Our Case Number: ABP-317660-23

Re: Busconnects Kimmage to city centre core bus corridor scheme
Kimmage, Dublin

Observation on Bus Connects Kimmage Core Bus Scheme

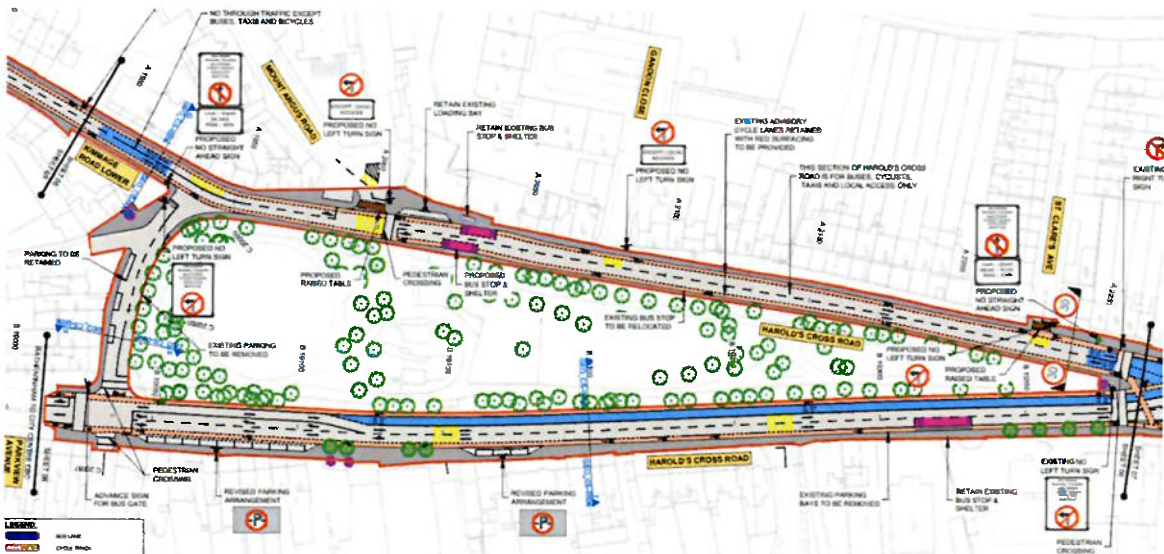
The current Bus Connects plans shows the removal of pedestrian footpath and a portion of the apron at the main gate at the south end of Harolds Cross Park as per the extract shown above.

1. I am concerned about destabilising both the railings and the adjacent mature trees. The tree survey for Bus Connects does not include the 7 mature trees in Harold's Cross Park that will be directly affected by the removal of this footpath. The 7no. Mature trees immediately inside the park railings will be greatly affected by works carried out under their canopy, which will cause root destabilisation and accelerate their decline. Even if this work is carried out to the specification for other trees surveyed for this scheme it will lead to the more rapid loss of these trees. Routing traffic immediately under the canopy of these trees will require that they need massive crown reduction which will lead to the speeding up of their decline and the earlier loss of these trees.

2. The park has no lighting and is closed after dark so does not provide an alternative route for pedestrian moving between Lower Kimmage Road and Harold's Cross Road as is stated in the documents provided. Both these roads have housing, shops & bus stops so this is currently a busy pedestrian route. The new layout proposed by Bus connects will force pedestrians to cross moving traffic 3 times to go between these roads where currently they can negotiate this route with only 1 street crossing. Removal of these pedestrian facilities negatively impacts access to and from the park and permeability in the general area of the park while significantly increasing traffic volumes. This is of particular concern at the morning school times when the bus gate at North West of the park is closed.

5. *Design Manual for Urban Roads and Streets (DMURS):* Minimum footway widths are based on the space needed for two wheelchairs to pass each other (1.8m). This is the only public footpath that is currently to public footpath width standards at access points to the park. The path width along the Lower Kimmage road where 2 access points to the park are located are 900mm wide at park gate points. This means that these paths do not allow for universal access and also mean a barrier has to be positioned along the path edge to prevent accidents between traffic and pedestrian. There does not seem to be any proposal for barriers.

6. The proposed increased width of the vehicular lane is in excess of what is required. The current width of the vehicular lane facilitates a two way traffic which works well. It reduces traffic speeds along this stretch of street and facilitates pedestrian movement across the road and entering and leaving the park. Existing parking bays also slows traffic movement along this busy pedestrian route between bus routes.

8. Traffic will now move along the line of the parks original railing and the buffer to damaging this original railing will be lost when the path is removed. This will put this historic park boundary in immediate danger of damage from fast moving traffic. Sections of railing along Lower Kimmage road were damaged by speeding traffic and have only recently been repaired.

The proposal to remove the footpath should be removed in total from the scheme. It is explicitly against the stated objectives of the Bus Connects scheme. It reduces pedestrian facilities purely to speed up private car traffic. It ignores the historic trees within the park which will be destroyed by the construction of a wider road service. It ignores the historic kerbing and railings to the park. It forces pedestrians on a roundabout route to facilitate private cars. There are two primary schools and one secondary school in the immediate area - this proposal will only hinder attempts to increase walking and cycling to school.
